Sunnyside Cogeneration Associates

RE: Sunnyside Refuse and Slurry C/007/0035
Request for Phase 1 Bond Release –
Excess Spoil Disposal Area #2 Phase 1 Reclamation

APPLICATION FOR COAL PERMIT PROCESSING

APPLICATION FOR COAL PERMIT PROCESSING
Detailed Schedule Of Changes to the Mining And Reclamation Plan

8-2

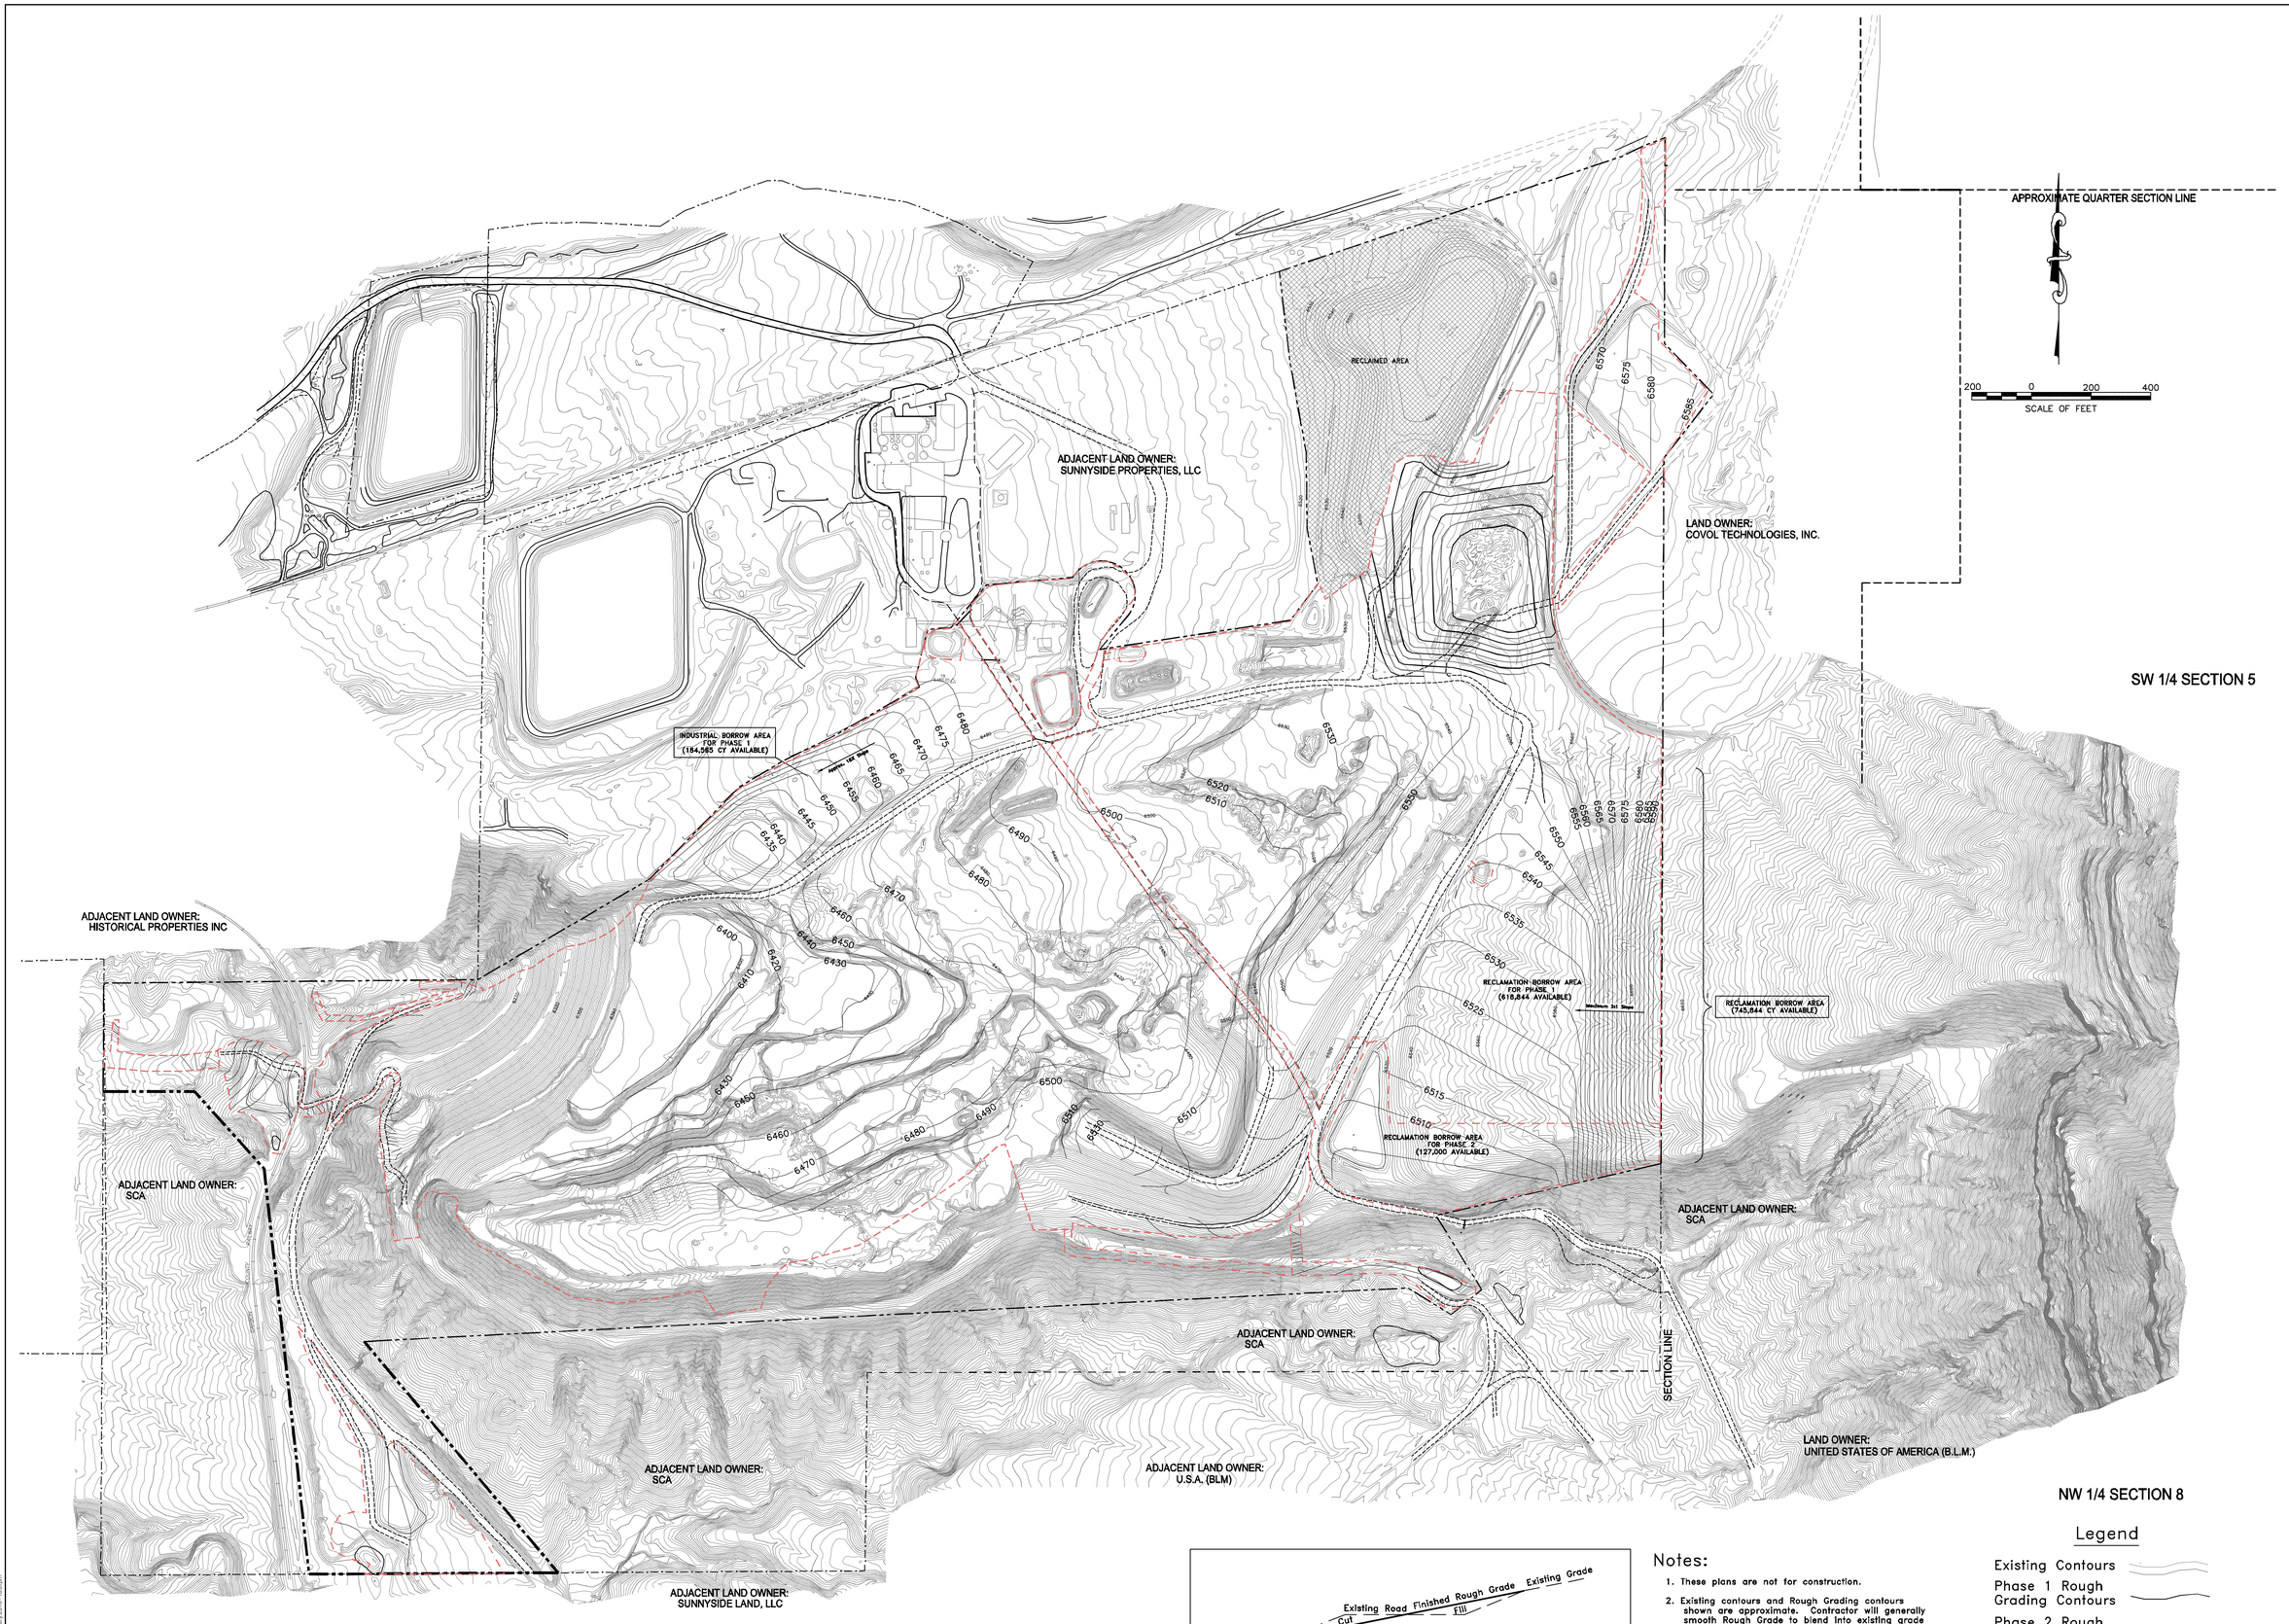
REV.	DATE	DESCRIPTION	BY	APP'D
7	1/16	EXCESS SPOIL DISPOSAL AREA, RECLAMATION UPDATE	AH	
6	11/10	BOUNDARY AND TOPO UPDATES	AH	
5	2/07	UPDATED PASTURE POND	AH	
4	12/05	EXCESS SPOIL #2 GRADING	AH	
3	9/02	2002 PERMIT RENEWAL	AH	
2	9/97	REVISED GRADING	KM	
1	7/94	ADDED COAL PILE AREA	AH

SHEET 8-3 OF

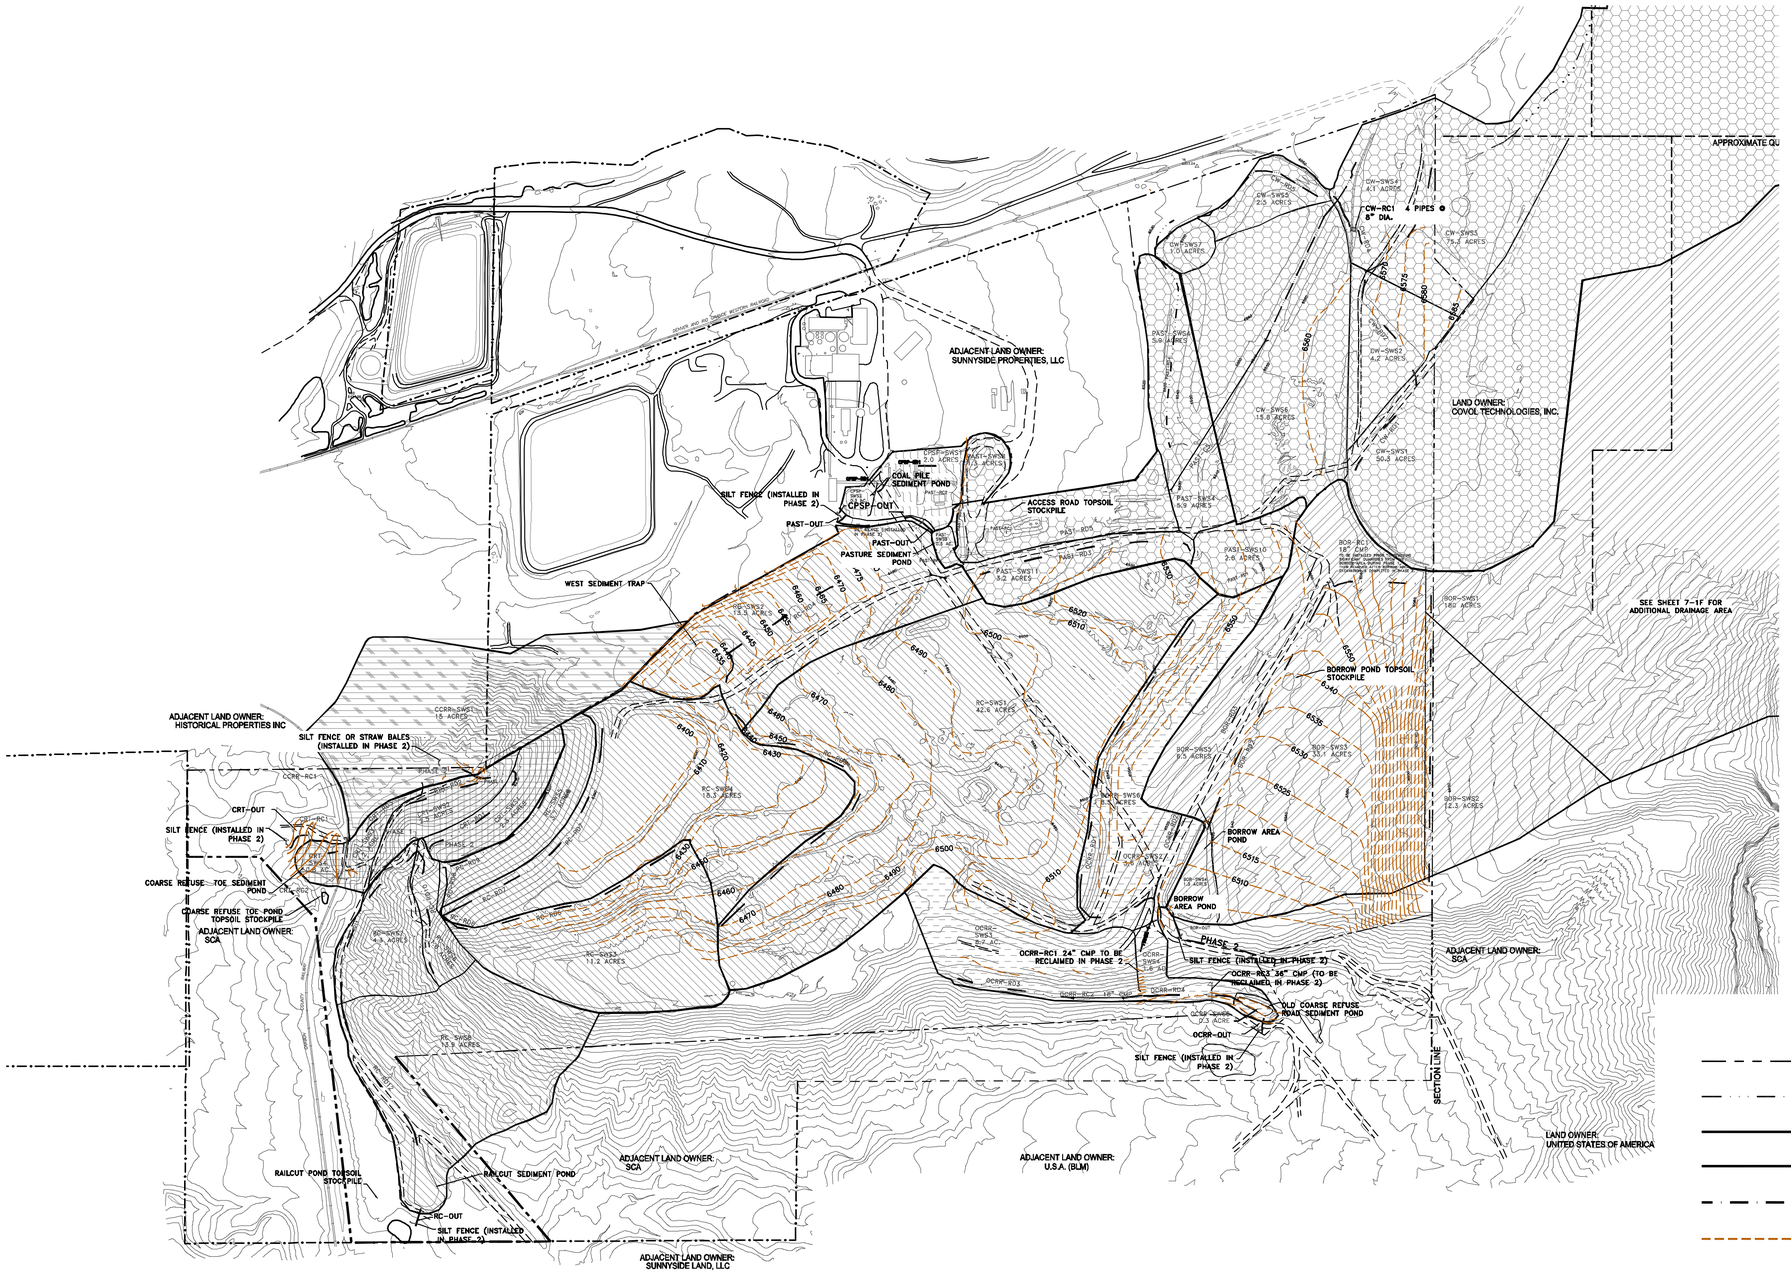
REV	DATE	DESCRIPTION	BY	APP'D
6	1/16	PHASE ONE RECLAMATION UPDATE	AH	
5	11/10	BOUNDARY AND TOPO UPDATE	AH	
4	2/07	PASTURE POND UPDATE	AH	
3	3/06	CLEAR WATER POND RECLASSIFICATION	AH	
2	9/97	PERMIT RENEWAL UPDATES	AH	
1	8/94	ADDED COAL PILE AREA	AH
